I am writing to voice my opposition to the proposal for the Sutton Forest Sand Quarry.

I am writing on behalf of the properties 2950, 2952, 2954 and 2956 Canyonleigh Rd, Canyonleigh, NSW 2577. Our family is the owner of one of these properties. This opposition is on the grounds of noise pollution, visual impact and night-time light pollution.

(Image 1)

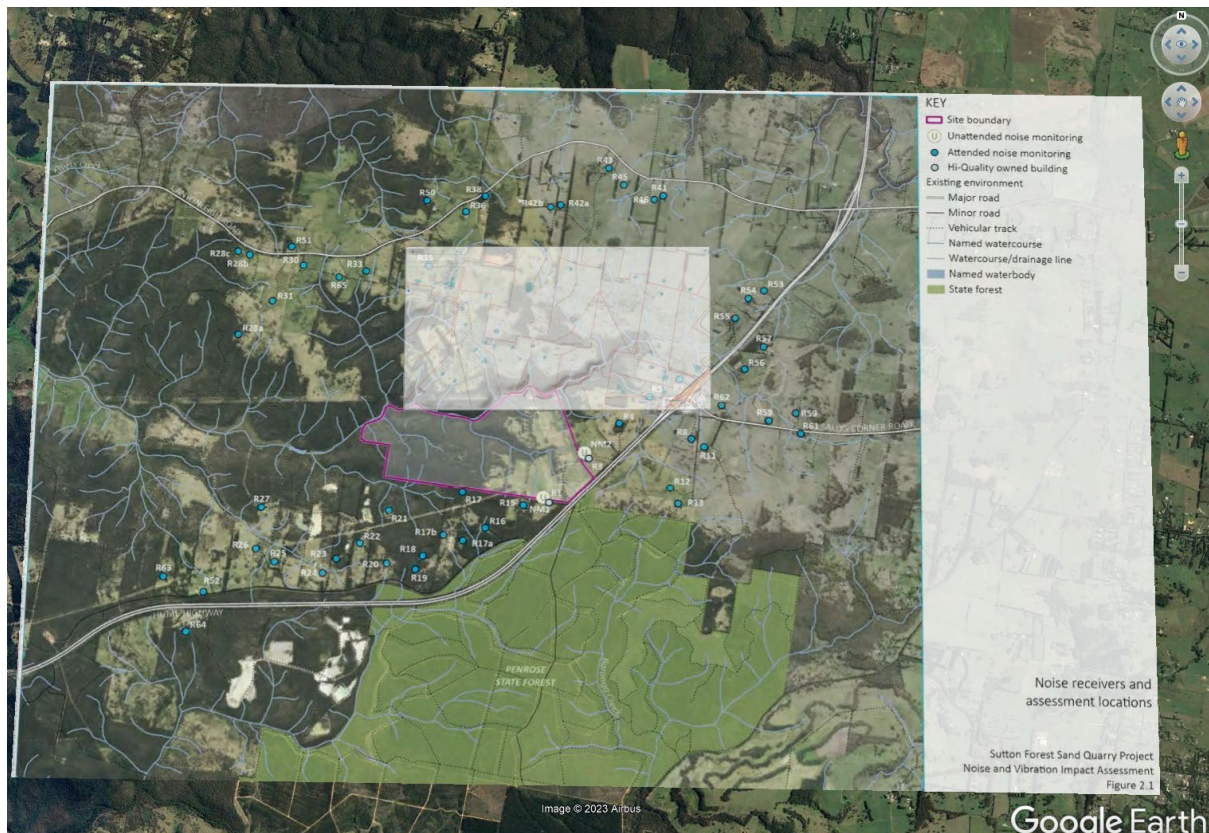
Firstly, I note that according to the noise level prediction in *Appendix O*, there were no noise predictions taken near our properties, which lie within 1.5km north of the proposed quarry. The next closest noise monitoring site (*Appendix O, Figure 2.1, Site 42A*) to our properties is 2.3 km north of the proposed quarry. This noise monitoring site (42A) is located behind a hill, while our properties are generally on a south facing slope - toward the proposed site, with no hill in the way (See Image 1 - Google Earth overlay of our properties against noise monitoring sites). The approved housing areas on each property are not located behind this hill, and lie facing the proposed quarry.

Likewise, while noise mitigation efforts have been taken to the east of the proposed site in the form of a bund, there are no noise mitigation plans to the north of the site.

There are currently newly built, under construction, and planned residential houses on these properties that are unaccounted for in the updated proposal.

I am concerned that if approved, noise levels from the site will unreasonably disturb the quiet of our property.

(Image 2)

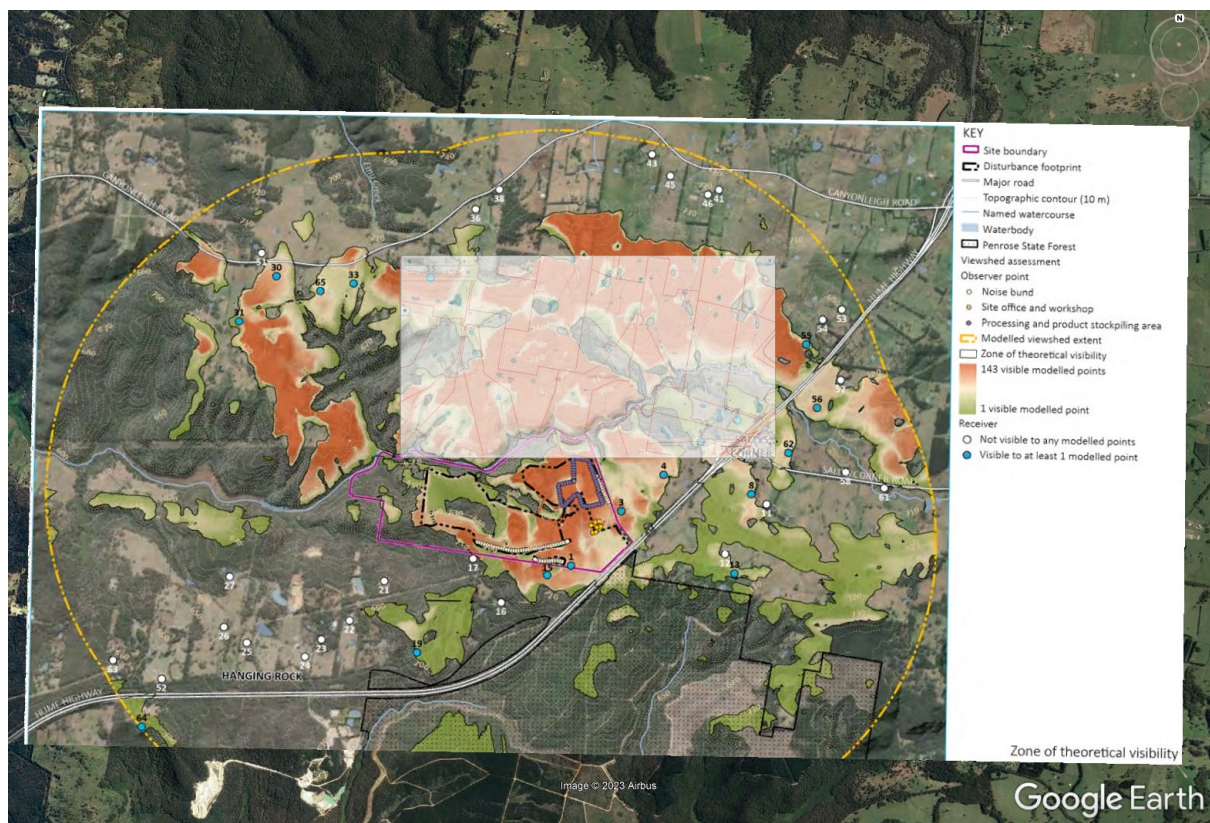
Similarly, in *Appendix S* - the visual impact assessment, we note that our properties with newly built, under construction, and planned residential houses are less than 1.5km away

from the proposed development, while the nearest closest observers point (*Appendix S, Figure 2.1, Site 46*) is 2.9 km away. Our properties were ignored by the visual impact assessment, despite an available access road being present for over three years. Likewise, the computer-modelled zone of theoretical visibility shows that the majority of each of our properties are covered by hundreds-tier of visible modelled points (*Appendix S, Figure 2.1*).

Current, under construction, and planned housing sites all lie within this zone. Please see Image 2 – Google Earth overlay of our properties against the computer-modelled zone of theoretical visibility.

We are concerned that if approved, the proposed quarry will unreasonably visually impact our property.
